**AMENDMENT TO REGULATING PLAN  
& SUBDIVISION STAFF REPORT****Date: June 15, 2017**

<b><u>NAME</u></b>	Jeffrey Quinnelly
<b><u>SUBDIVISION NAME</u></b>	North McGregor Subdivision, Quinnelly-Hale Addition to
<b><u>LOCATION</u></b>	406 & 456 North McGregor Avenue and 3772 & 3774 Sheips Lane (Northeast corner of North McGregor Avenue and Sheips Lane).
<b><u>CITY COUNCIL DISTRICT</u></b>	District 7
<b><u>PRESENT ZONING</u></b>	Neighborhood Center and Neighborhood General
<b><u>PROPOSED ZONING</u></b>	Village Center
<b><u>AREA OF PROPERTY</u></b>	1 Lot/ 1.0± Acres
<b><u>CONTEMPLATED USE</u></b>	<p>Subdivision to create one legal lot of record from five legal lots of record, and an amendment to the Village of Spring Hill Regulating Plan to change the regulating sub-districts from Neighborhood Center and Neighborhood General to Village Center.</p> <p><b>It should be noted, however, that any use permitted in the proposed district would be allowed at this location if the zoning is changed. Furthermore, the Planning Commission may consider zoning classifications other than that sought by the applicant for this property.</b></p>

# SITE PLAN

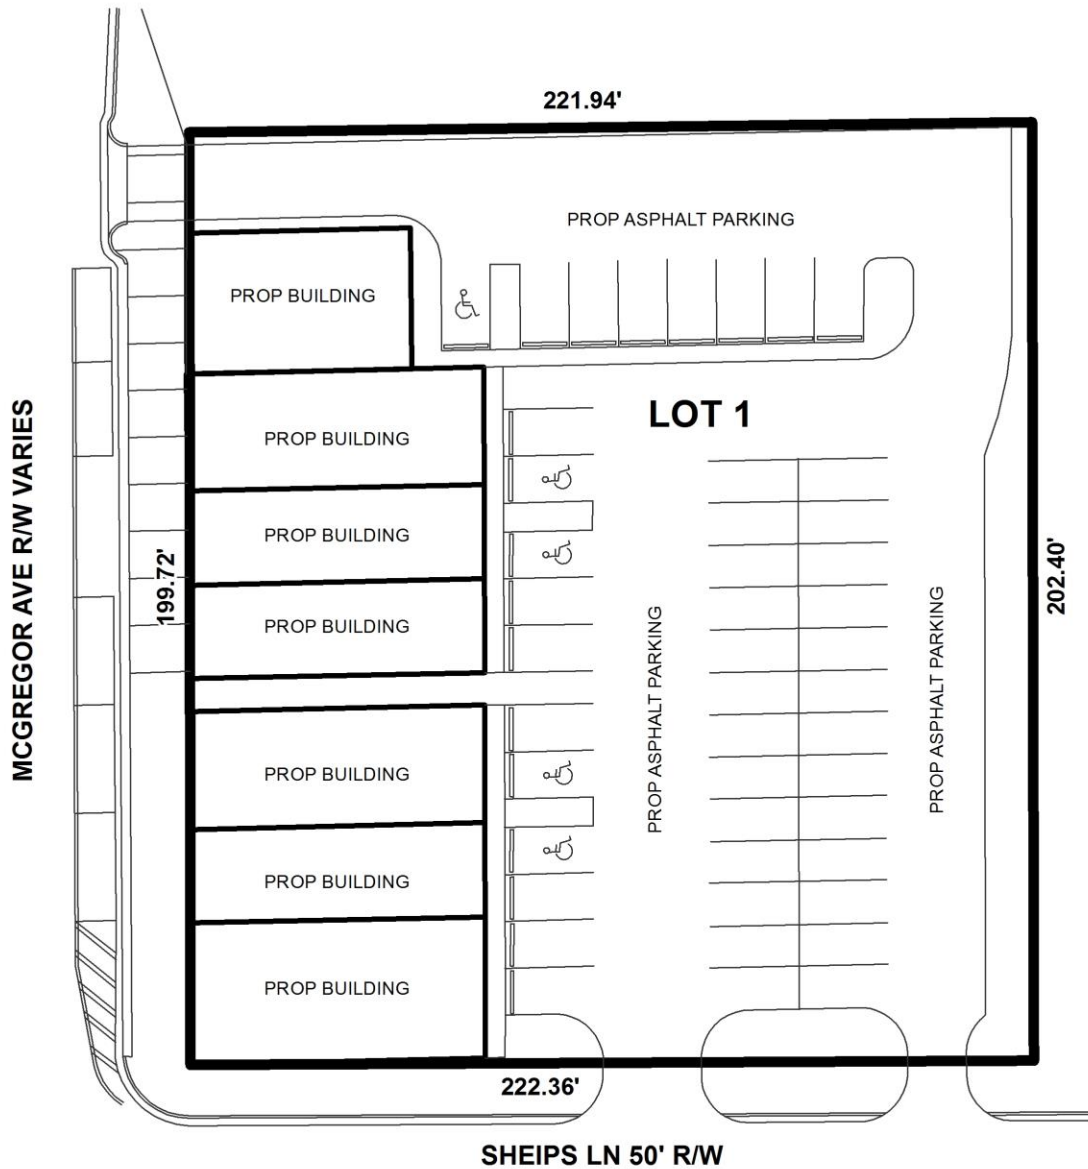
The site plan depicts the demolition of an existing dwelling on the proposed lot, with two other dwellings having been demolished by the applicant with appropriate permits in 2015 and 2013. The proposed redevelopment of the site would include seven buildings (or suites) with footprints ranging from 1,200 square feet to 1,800 square feet and a parking area with 45 parking spaces behind the buildings. Based on the total square footage of buildings provided, it appears that all structures will be two-stories tall.

Per Traffic Engineering comments, the site should be limited to one curb cut per street frontage, with the size, location and design to be approved by Traffic Engineering and conform to AASHTO standards. As the site plan illustrates two curb cuts to Sheips Lane, one of the curb

cuts will have to be removed to comply with these requirements. One of the drive aisles is 24' wide, thereby allowing two-way traffic for interior circulation to the second drive aisle which is 20' wide for one-way traffic to the proposed curb cut.

The site plan provided does appear to be to-scale, however, no scale is provided. While amendments to the regulating plan are not site plan specific, it should be noted that the site plan submitted with the application does not comply with the requirements of the Village Center sub-district of the Village of Spring Hill Traditional Center District Regulating Plan. Furthermore, because the site plan depicts multiple structures separated by a 7' wide walkway, a Planned Unit Development may be required prior to development. It should be noted that Planned Unit Development approvals are site plan specific.

As mentioned, the site plan depicts 45 parking spaces which exceed the minimum of 44 parking spaces required for the proposed size of the structures, provided that there are no restaurants on site. The placement of a restaurant would increase parking requirements beyond what the site is able to accommodate. Furthermore, there is a proposed parking space in the parking lot that is sub-standard in size. Therefore, this space should be striped or landscaped to make it obvious that no parking is allowed in that area. Due to the number of parking spaces to be provided, a photometric plan should be submitted at time of application for land disturbance permits.

The site plan also includes the provision of five 8' x 20' parallel parking spaces in the right-of-way along North McGregor Avenue. Per Traffic Engineering, these improvements are anticipated to be completed by an upcoming City resurfacing project and Traffic Engineering will assist with appropriate layout of the on-street parking. It should also be noted that sites developed under the Traditional Center District regulations should not have surface parking lots closer to a street frontage than 30' per Section 64-3.H.6.a.(4). of the Zoning Ordinance, and it appears that the parking area will be approximately 12' from Sheips Lane.

The site plan does not provide any tree planting or landscape area calculations. Sites developed under the Traditional Center District Regulating Plan Village Center sub-district are required to have a minimum of ten percent of the site to be landscaped. Without landscape area calculations provided, staff cannot determine if the site will be in compliance, but it does not appear to meet the minimum requirement.

Properties in the Traditional Center District Regulating Plan Village Center sub-district are required to provide a 12' wide sidewalk along all frontages, which the applicant appears to propose. However, per the Traditional Center District regulations, if there is not sufficient room in the existing right-of-way to accommodate a 12' wide sidewalk, dedication should be made to the City so that the sidewalk will be in the right-of-way. Neither the proposed site plan, nor the preliminary plat makes it clear if the sidewalk will be in the right-of-way or if dedication will be made to comply with this requirement. The sidewalk should be clearly shown on the site plan,

along with any required street trees (per Section VIII.G. of the Subdivision Regulations), and proposed street lights.

The site plan does not illustrate a dumpster, nor is there a note stating that curb-side pickup will be utilized. The applicant should revise the site plan to illustrate all existing dumpsters, with any dumpsters to be screened from view and in compliance with Section 64-4.D.9 of the Zoning Ordinance or a note stating curb side pickup will be utilized.

As the property abuts R-1, Single-Family Residential property to the East, a residential buffer should be provided. The site plan should be revised to illustrate a 3'-6' high privacy fence, garden wall, or hedge, per Section 64-3.H.4.a.(6). of the Zoning Ordinance.

Finally, it should be noted that the proposed site plan misspells Sheips Lane as "Scheips Lane".

- 1) either revision of the application to request a different sub-district of the Village of Spring Hill Traditional Center District Regulating Plan (specifically, Neighborhood Center), or submit a rezoning application to change the underlying zoning district of the site;

- 2) either revision of the site plan and narrative to illustrate all structures will be connected, or submittal of a Planned Unit Development application;

- 3) provision of information regarding the proposed uses of the new structures on site plan and narrative;
- 4) revision of the plat to depict dedication along North McGregor Avenue and Sheips Lane to accommodate the required 12' wide sidewalk if necessary;

- 5) dedication of the corner radii at the intersection of North McGregor Avenue and Sheips Lane per Section V.D.6. of the Subdivision Regulations;
- 6) correctly spell Sheips Lane;

- 7) provide a scale on the site plan;
- 8) provision of landscape area calculations and tree plantings;
- 9) depiction of required street trees in the right-of-way, as well as proposed street lights;

- 10) either provision of a dumpster connected to sanitary sewer and appropriately screened, or placement of a note stating that curbside pickup will be utilized;

- 11) provision of a 3'-6' high privacy fence, garden wall, or hedge along the Eastern property line where the site is adjacent to R-1, Single-Family Residential District per Section 64-3.H.4.a.(6). of the Zoning Ordinance;

- 12) revision of the sub-standard parking space to either be landscaped or striped to clearly prohibit parking in the area;
- 13) placement of a note on the site plan stating that any on-street parking will require approval from Traffic Engineering as well as a non-utility right-of-way use agreement;

- 14) revision of the site plan to provide parking setback from Sheips Lane by at least 30' per Section 64-3.H.6.a.(4). of the Zoning Ordinance;
